Final Drainage Report

For:
Didleau Subdivision Filing 1

Project No. 2019.012

Please add PCD File No. MS206

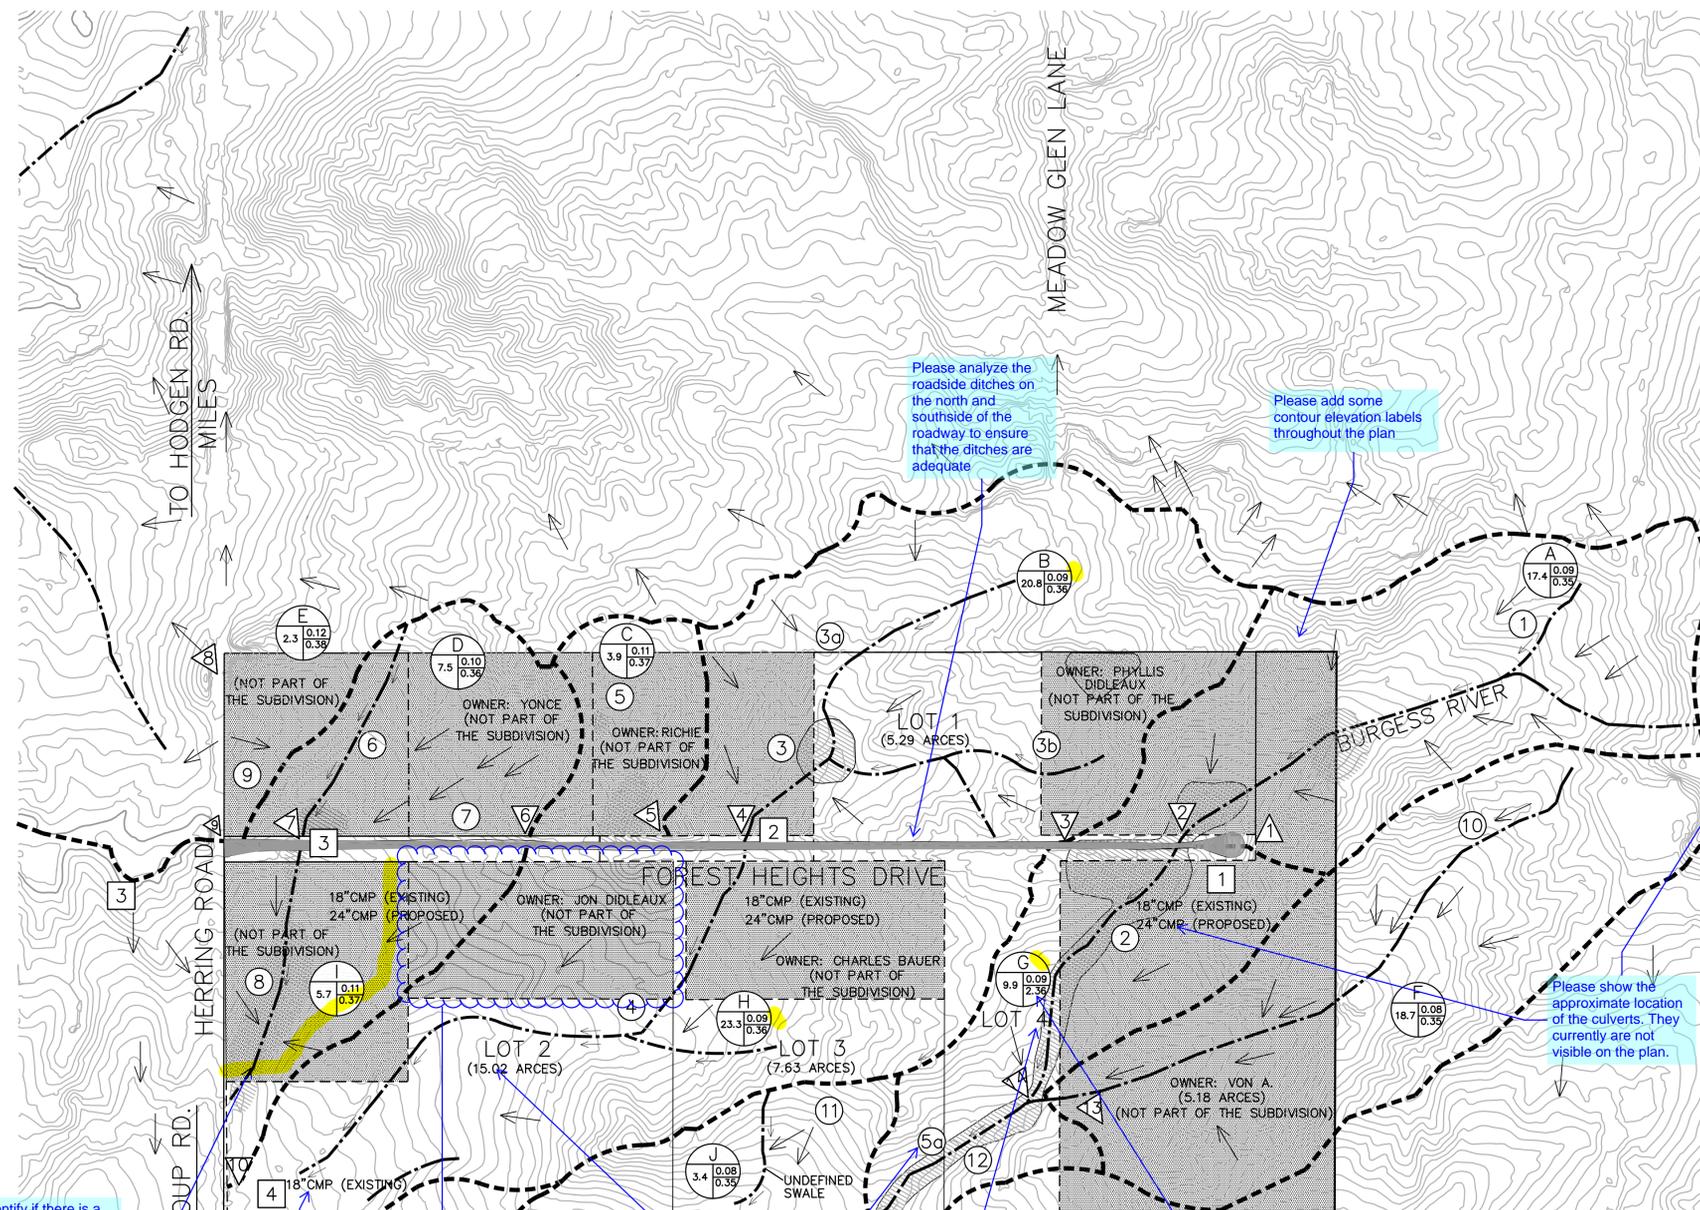
Swale 1 appears to terminate at DP 2 per the drainage plan. Please revise accordingly.

Swale 8 is identified above. Please revise the text accordingly so that the correct swale is identified.

Please provide additional discussion regarding swale 8. It appears that swale 8 outfalls to the roadside ditch along Herring Road. Indicate whether the ditch is adequate to accept this flow and whether the flow is contained within the ditch as it flows to the south to DP11.

swale 11 shown on the drainage map. Revise accordingly. Please identify the total flow at DP12

Please show this design point on the drainage map.
